Access Compliance Report

Public Rights-of-Way

(Curb Ramps)

Intersection ID: 10569	Main Street: PLYMOUTH_AV	Cross Street: BANCROFT_ST	Location:	E
ADA ID: 151979BF528D	Ramp Type: Perp	Initial Pass/Fail: Fail	Overall Compliance: No	Severity Score: 10
Codes/Mitigation Info/Possible Solution		Field Measurements/Component Compliance

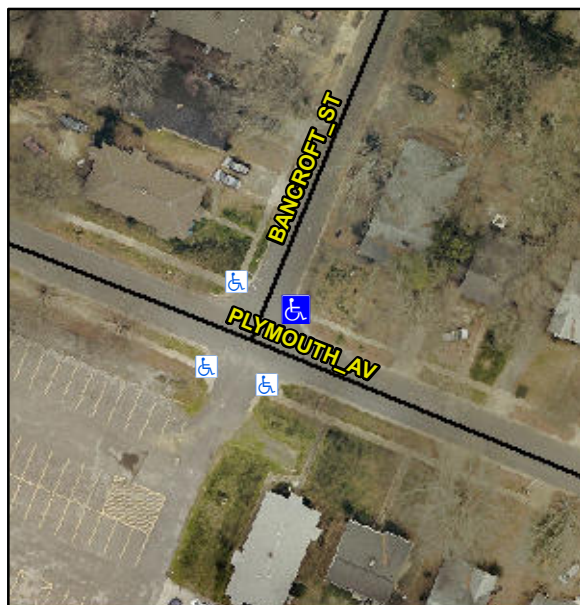
Not Found, R304.5.1, R304.5.3

Compliance	Description	Data	Compliance	Description	Data
N/A	Ramp Length (in)	25.0	Yes	Ramp Slope (%)	7.1
No	Ramp Width (in)	44.0	No	Ramp XSlope (%)	4.3
N/A	Flare Type LT	N/A	N/A	Flare Type RT	N/A
N/A	Flare Slope LT (%)	N/A	N/A	Flare Slope RT (%)	N/A
N/A	Flare Traversable LT?	N/A	N/A	Flare Traversable RT?	N/A
N/A	Landing Length (in)	N/A	N/A	DWS Provided?	N/A
N/A	Landing Width (in)	N/A	N/A	DWS Contrast?	N/A
N/A	Landing Slope (%)	N/A	N/A	DWS Length (in)	N/A
N/A	Landing X Slope (%)	N/A	N/A	DWS Full Width?	N/A
N/A	Landing Curb? (Y/N)	N/A	N/A	DWS Offset (in)	N/A
N/A	Shared Landing?	N/A			
N/A	Gutter Ponding?	N/A	N/A	Gutter Slope (%)	N/A
N/A	Gutter Lip Ht (in)	1.5	N/A	Gutter X Slope (%)	N/A
N/A	Painted X Walk1?	No	N/A	Painted X Walk2?	N/A
	X Walk 1 Direction	To NW		X Walk 2 Direction	N/A
N/A	X Walk 1 Width (in)	N/A	N/A	X Walk 2 Width (in)	N/A
	X Walk 1 Slope (%)	3.4		X Walk 2 Slope (%)	N/A
	X Walk 1 X Slope (%)	3.9		X Walk 2 X Slope (%)	N/A

Remove & Replace Entire Ramp.
